- 3 142 -148 Cox's Road, North Ryde - Alterations and additions to the existing building to accommodate 135 place child care centre on the first floor. The hours of operation are between 6:30am and 7:00pm Monday to Friday. The development also involves a change of use of tenancy 5 and 7 on the ground floor to office, increasing in parking from 56 to 58 spaces, 2 business identification signs and strata subdivision - LDA2019/0189**

**File Number:** GRP/09/6/12/1/2 - BP20/907

### City of Ryde Local Planning Panel Report

<b>DA Number</b>	LDA2019/0189
<b>Site Address &amp; Ward</b>	142 -148 Cox's Road, North Ryde Lot 41 in Deposited Plan 560408 Lot 3 in Deposited Plan 220894 West Ward
<b>Zoning</b>	B1 Neighbourhood Centre
<b>Proposal</b>	Alterations and additions to the existing building to accommodate 135 place child care centre on the first floor. The hours of operation are between 6:30am and 7:00pm Monday to Friday. The development also involves a change of use of tenancy 5 and 7 on the ground floor to office, increasing in parking from 56 to 58 spaces, 2 business identification signs and strata subdivision.
<b>Property Owners</b>	Alramon Pty Ltd
<b>Applicant</b>	EVMR Pty Ltd/As

**Figure 14** – Proposed First Floor Plan indicating the location of the outdoor play spaces within the proposed childcare centre.

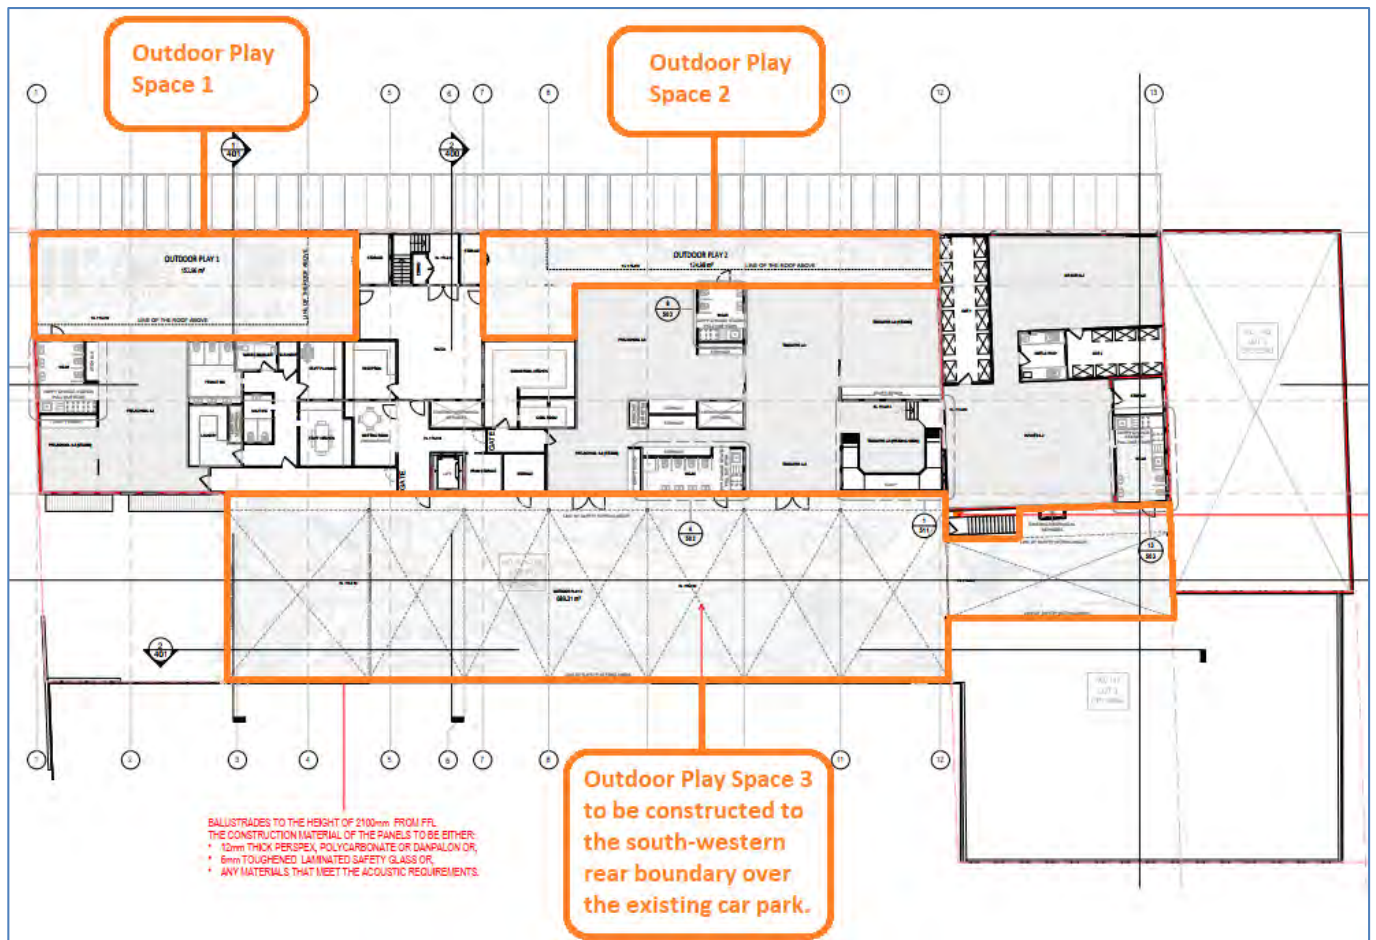
The proposed outdoor play spaces are each proposed with surrounding 2.1 metre acoustic walls. This requires that the existing front balconies be occupied by two of the play spaces, with a rear extension required to accommodate the third and largest play space. The layout of the play spaces across the first floor are shown within **Figure 14** and detailed sections of the acoustic walls are shown within **Figure 15**. Outdoor play spaces that are bound by walls of at least 1.4 metres in height contribute to the calculation of gross floor area, and this information was provided to the applicant in the Council RFI.

**Figure 18** – Extract of applicant's submitted first floor plan, detailing the location of the solid 2.1m high acoustic wall to surround the outdoor play spaces, and full height Perspex or glass panels to Outdoor Play Space 1 and 2.

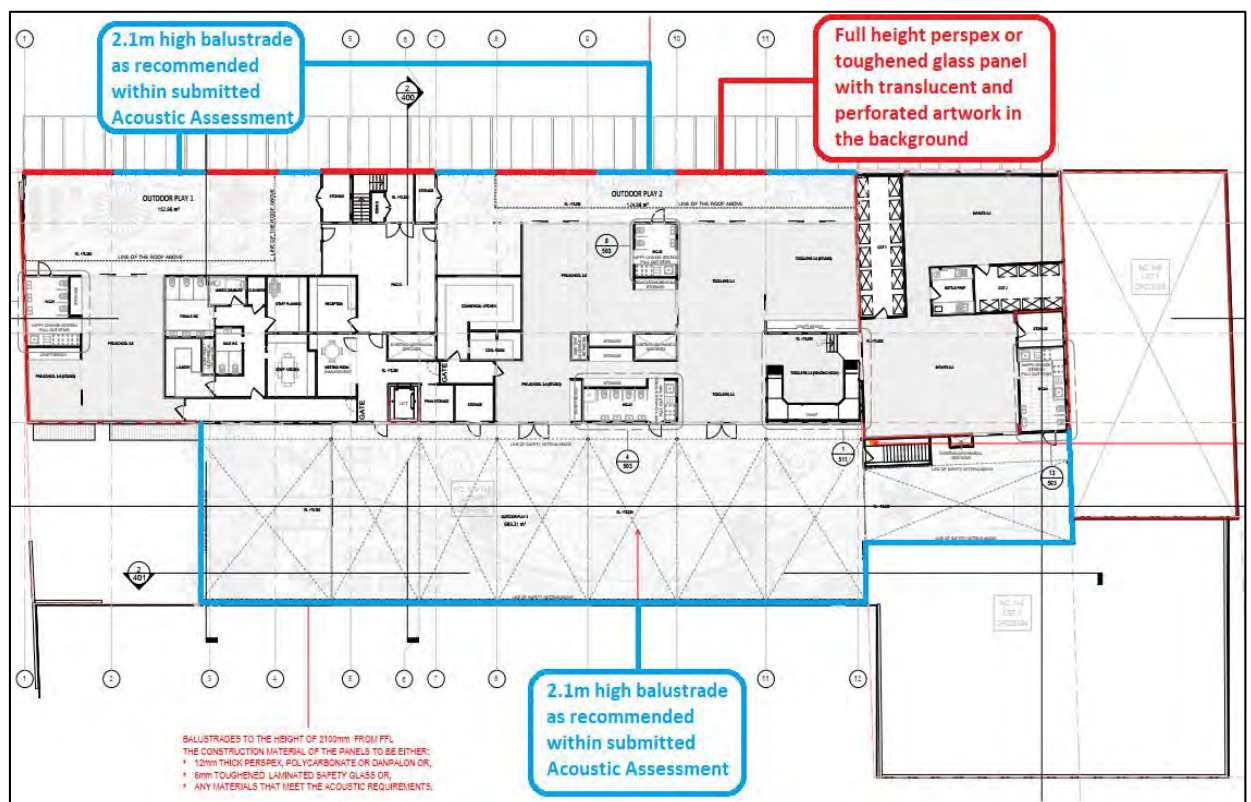
Council does not agree with the exclusion of Play Space 1 and 2 on the basis it is unroofed. The definition relating to the exclusion of terraces and balconies does not reference the need of the balcony or terrace to be roofed, rather it refers only to include a wall height greater than 1.4 metres in which these two areas do.

The applicant's Clause 4.6 has not included the play area at the rear of the site. Council is of the view that this space needs to be included due to the height of the walls surrounding this space being 2.1m.

**Figure 19** – Proposed First Floor Plan indicating the location of outdoor play space 1 and 2 within the proposed childcare centre.

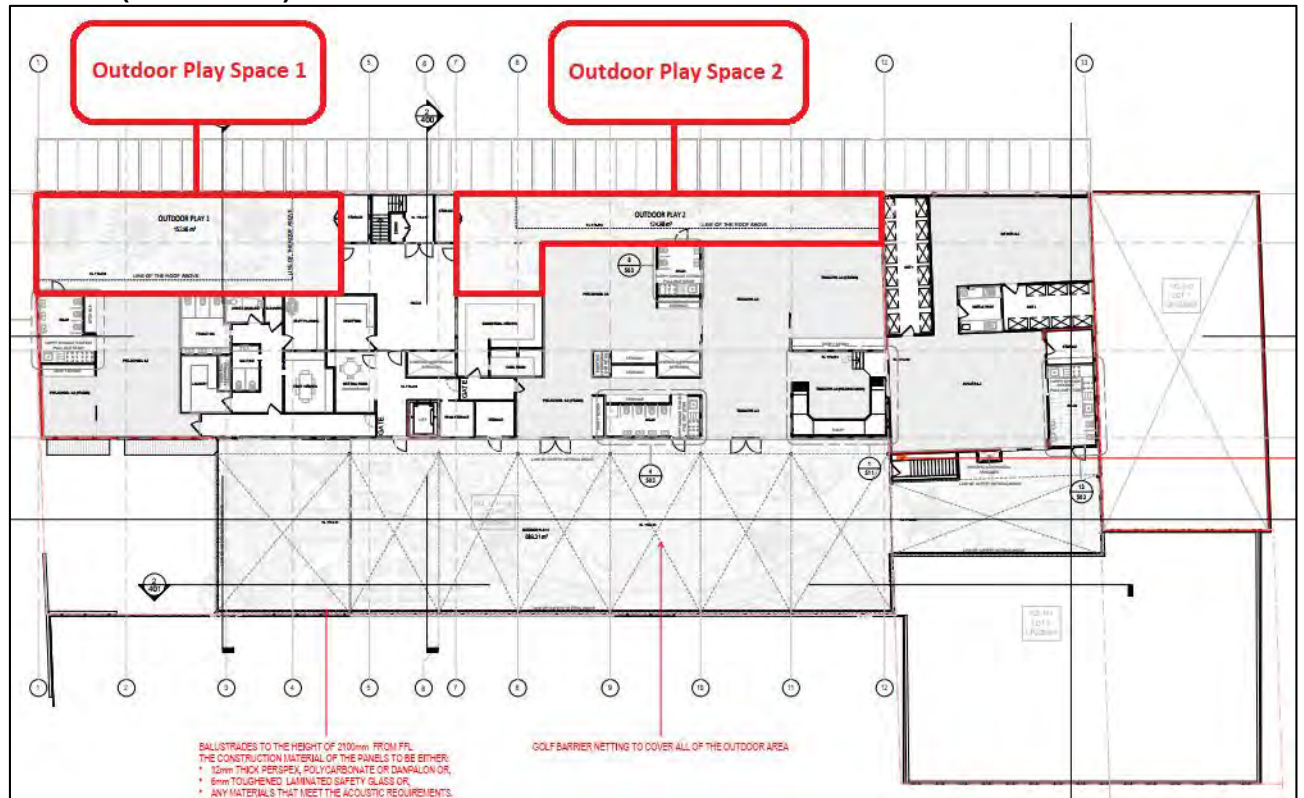
The Applicant's Clause 4.6 contends that Play space 1 and 2 are unroofed and are excluded from the GFA calculation. The play spaces have a combined area of 277.94m<sup>2</sup>. The written variation has been provided on the basis of including northern play area and indicates there is a resultant FSR of 0.82:1 and is seeking a variation of 59.17m<sup>2</sup> only. The proposed play spaces are identified in **Figure 19**.
